CITY OF DELAND
EGULAR MEETING OF THE HISTORIC PRESERVATION BOARD
NOVEMBER 7, 2024 AT 5:00 PM
CITY HALL, COMMISSION CHAMBERS
120 SOUTH FLORIDA AVENUE

RE: **Certificate of Appropriateness (New Construction) for a multi-family building at 225 W. New York Ave.**
Application No.: HPB24-204
Applicant: Mark Watts, Esq., *Cobb Cole*
Owner: Axia Partners, LLC
Florida Master Site File: None
Zoning District: C-2A
Current Use: Vacant

RE: Approved with conditions – Certificate of Appropriateness
New Construction (HPB24-144)
Meeting Verification – Historic Preservation Board
225 W. New York Ave.

1 E-01 SOUTH ELEVATION (STREET FACADE)
SCALE: 3/32" = 1'-0"

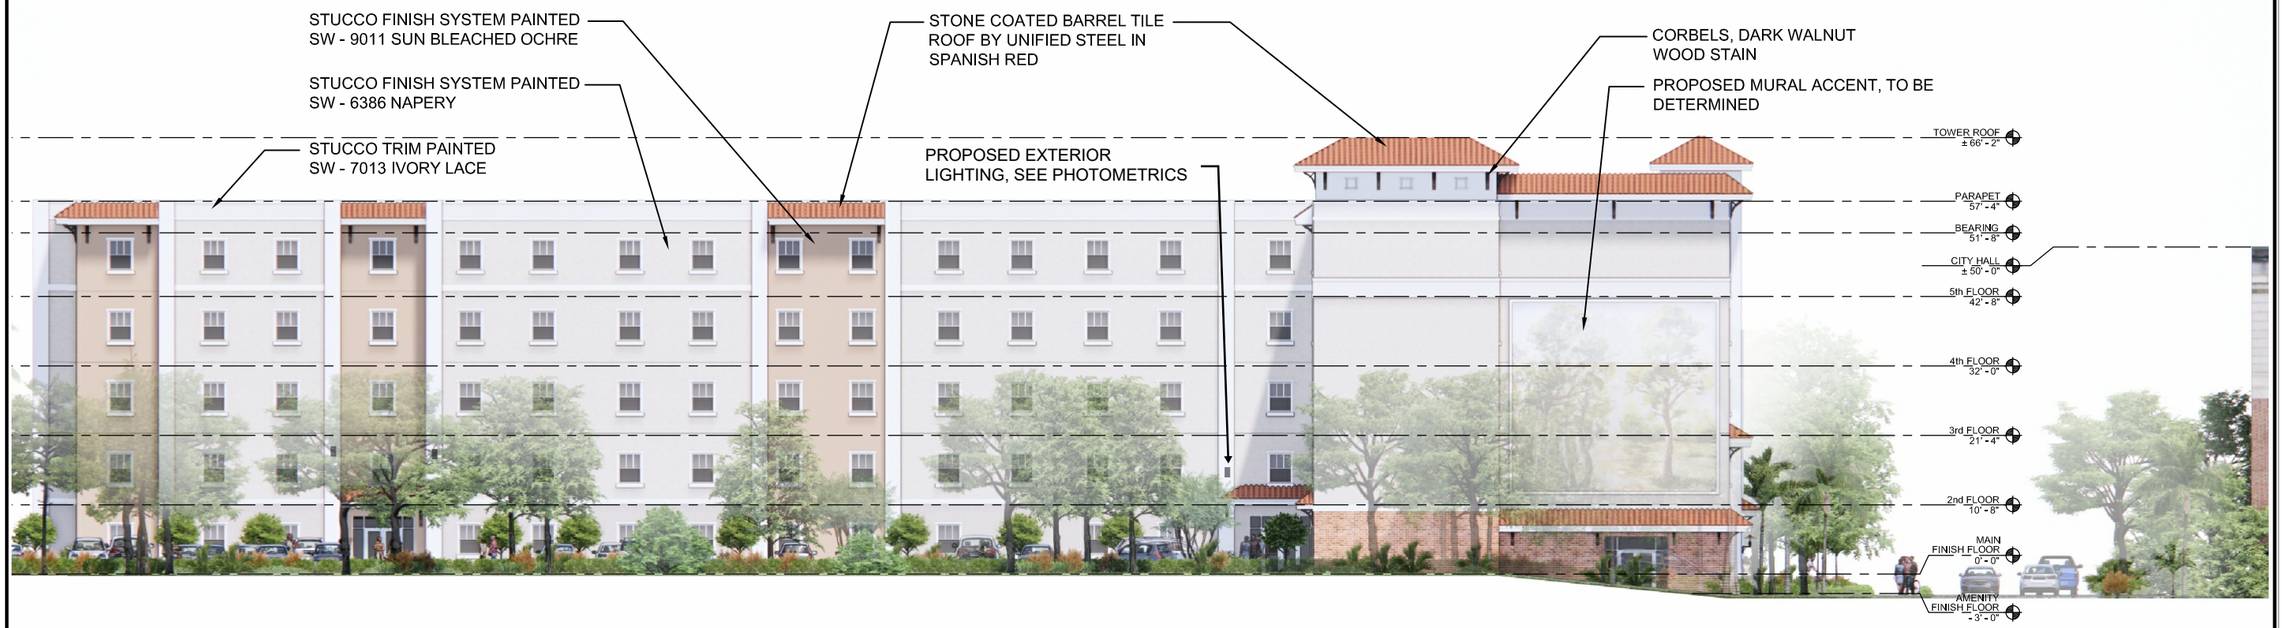
1) The mass and scale of the proposed building shall be reduced and the design modified to be compatible with the contiguous properties and surrounding structures. and;
2) Additional brick be incorporated into the exterior, specifically the South (New York Ave.) façade, on the tower potion, above storefront doors on floors 2-5.

The proposed building massing is not very similar to the other buildings within the district, especially as being the tallest building in the immediate block. However, the applicant has now incorporated a roof trellis, additional exterior brick on the tower potion, above storefront doors on floors 2-5, and additional landscaping along New York Avenue to achieve similar massing as other buildings within the district.

The south side of this building, facing New York Ave. has majority of the architectural features, such as change in materials, color, and storefront windows on first floor whereas the other three sides have less enhanced architectural features.

The applicant has revised the building elevations to reflect these conditions, and is seeking to have the conditions removed. The applicant has had a Class IV site plan reviewed by the Technical Review Committee (TRC) and has some outstanding technical staff comments that will need to be addressed prior to scheduling Planning Board and City Commission meetings. The Certificate of Appropriateness (COA) is in addition to these meetings, but the Historic Preservation Board purview is solely on the appearance of the building and how the features of the proposed building would be visually compatible with the existing contributing structures in a designated Historic District.
